Appeal by Hallam Land Management Ltd
Land North of A507, West of A10, Buntingford

Highways Statement of Common Ground between
Hertfordshire County Council as Highway Authority
and
East Hertfordshire District Council as Local Planning Authority
and
Hallam Land Management
June 2026

Report Ref: HCC-Ridge-Tt-HSoCG

LAND NORTH OF A507 AND WEST OF BUNTINGFORD: HIGHWAY ACCESS

Section B
Scale, 1:20

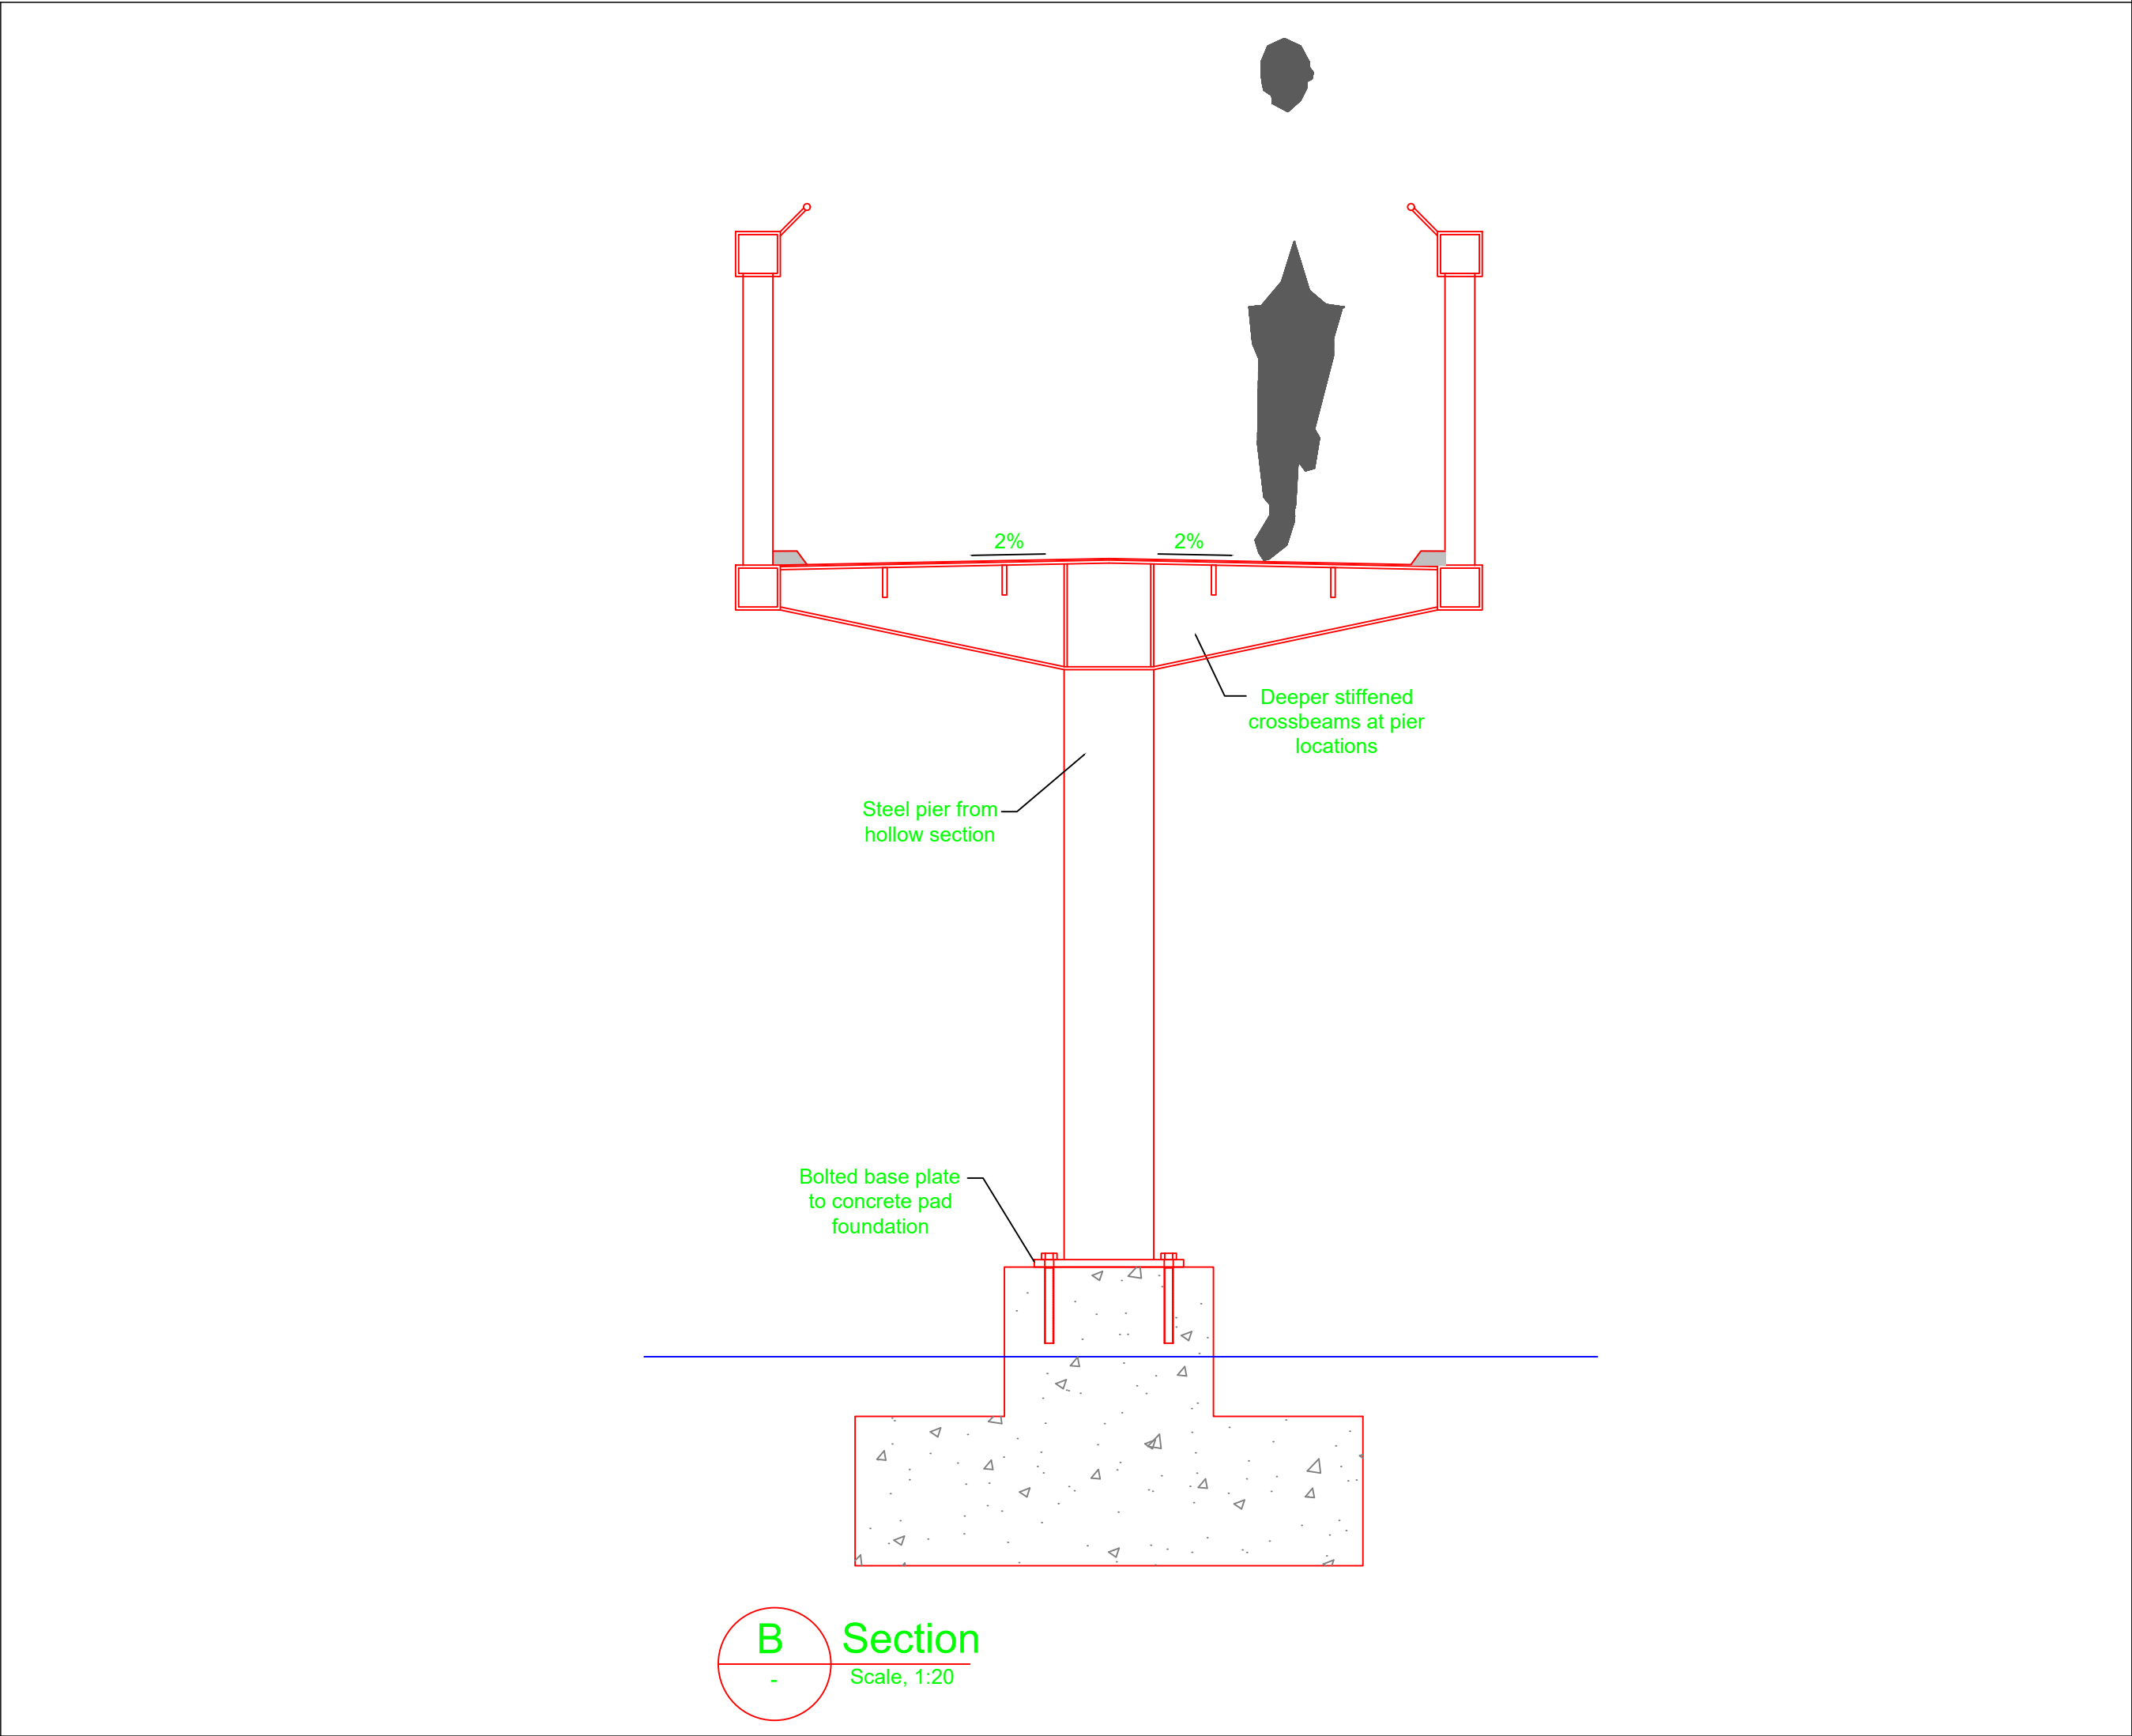
Drawing 23161 – 032 Rev P1

- 2.11 After due and careful consideration the audit team have been unable to identify any areas of concern in terms of highway road safety associated with the information portrayed on this drawing for this stage of road safety audit. See Also Comment 3.2

- 3.1 One of the drawing numbers is illogical and it has been assumed that this is a drafting mistake and will be rectified as the scheme progresses.
- 3.2 The highway authority has requested that the introduction of a Toucan Crossing for the southbound approach to the Baldock Road roundabout junction be considered in terms of safe operation. The audit team's observations are listed below, all carrying equal significance and are in no particular order.

PROJECT REF: 23161
DRAWING No: 022

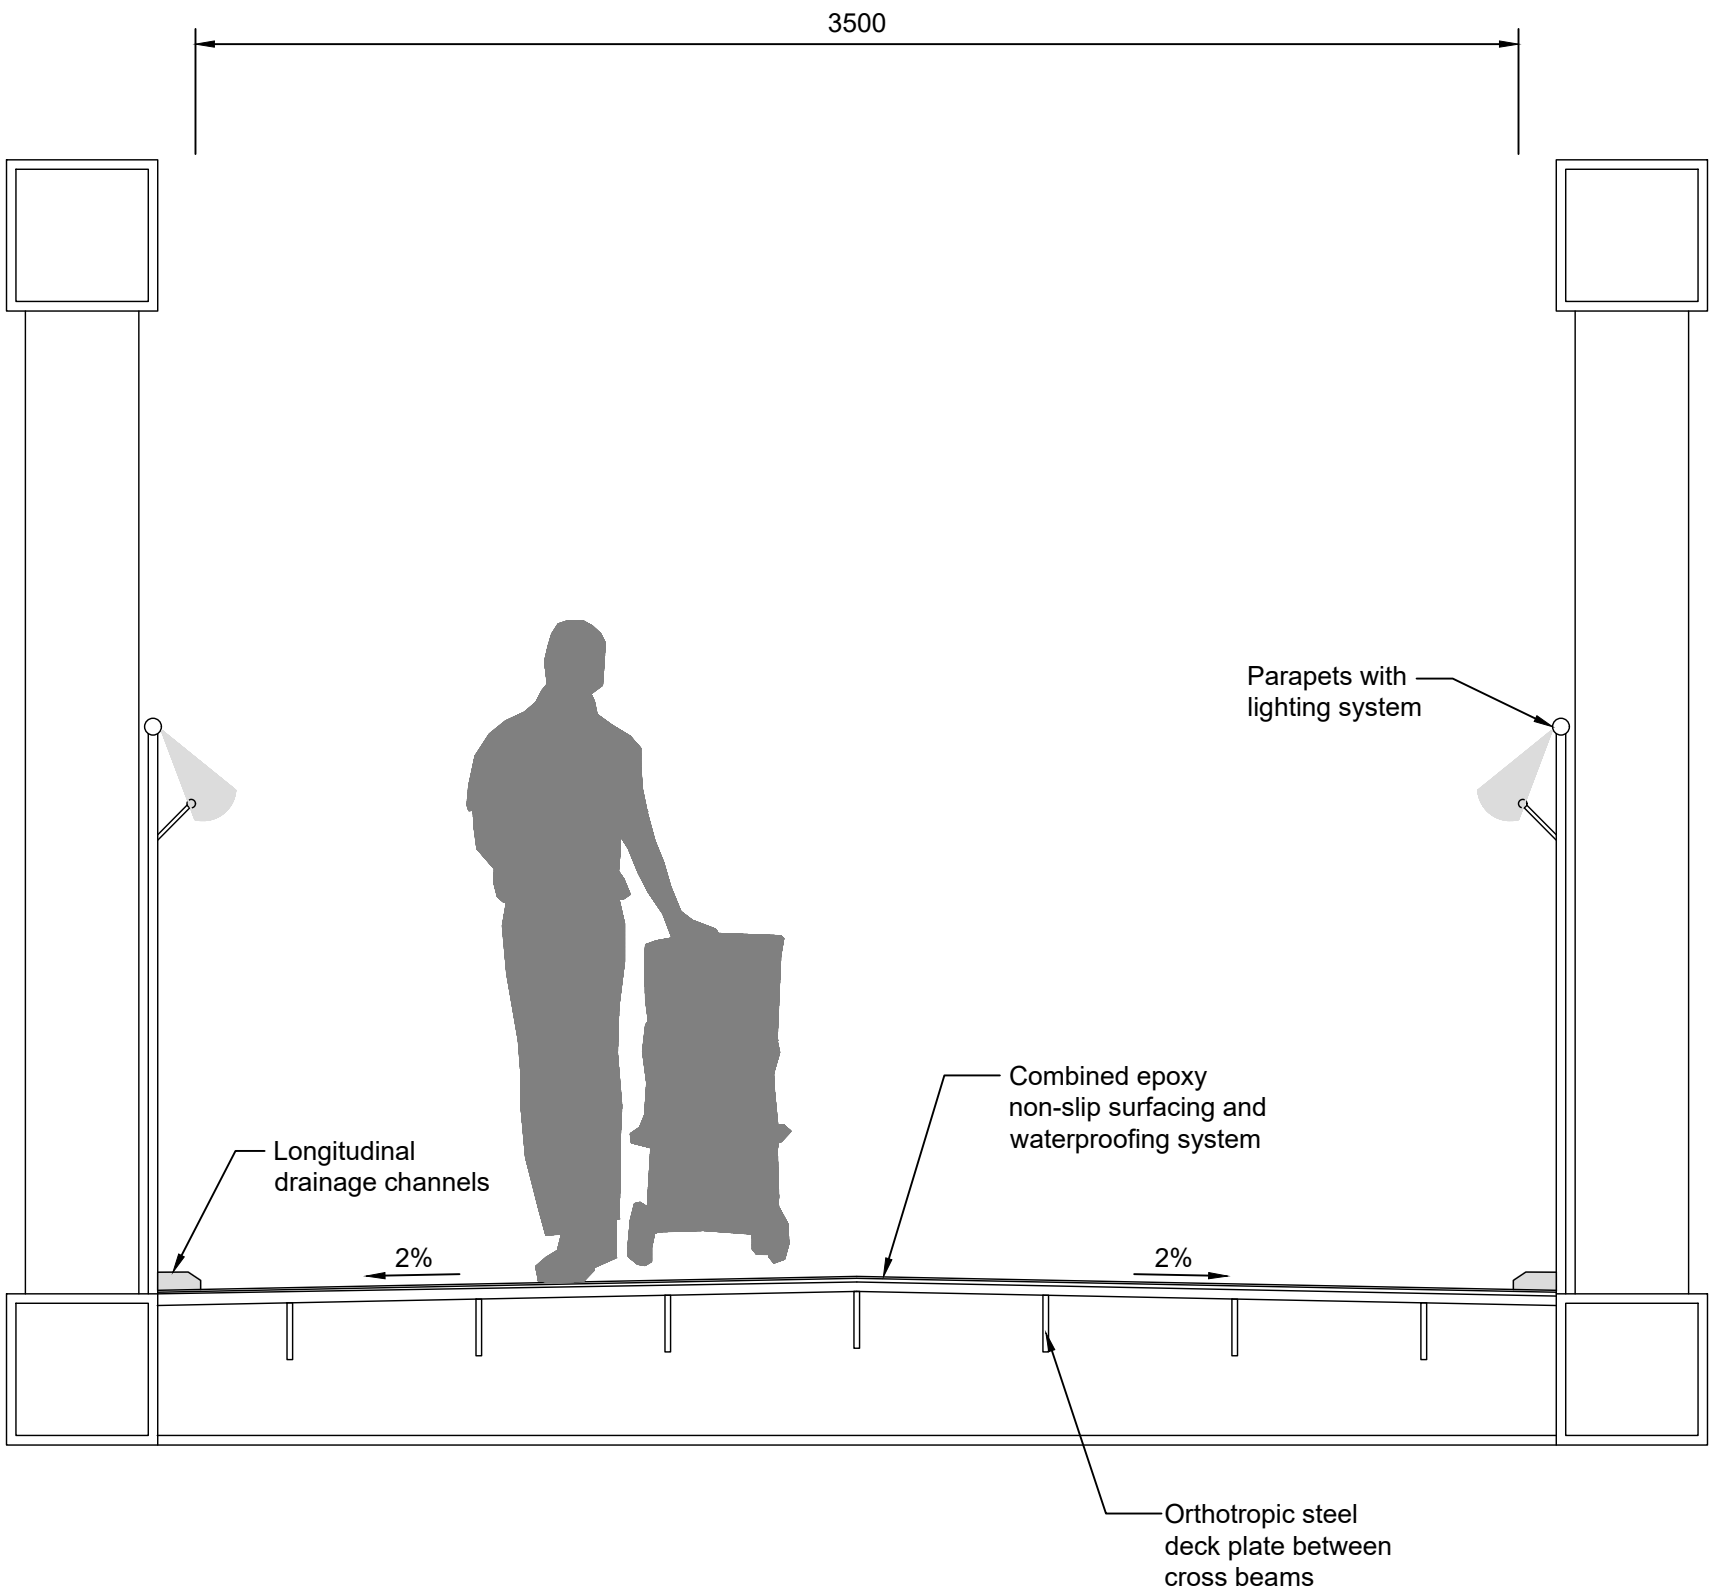
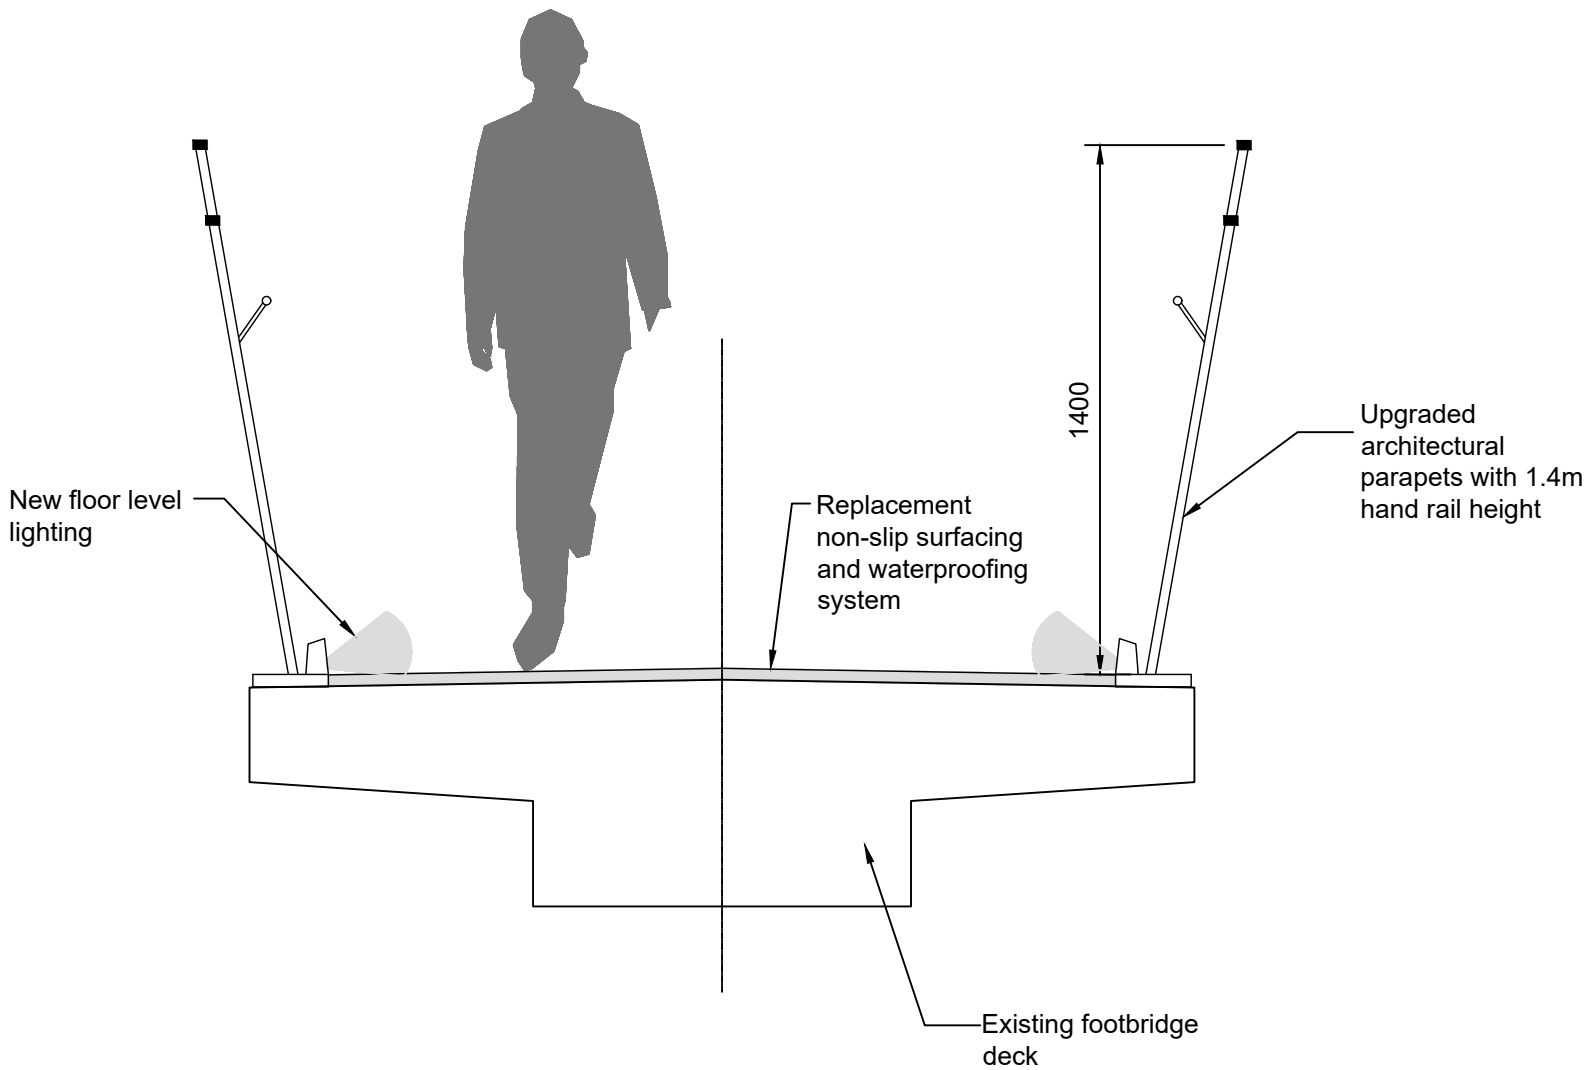
Drawing 23161 – 022 Rev P2

- 2.10 After due and careful consideration the audit team have been unable to identify any areas of concern in terms of highway road safety associated with the information portrayed on this drawing for this stage of road safety audit.
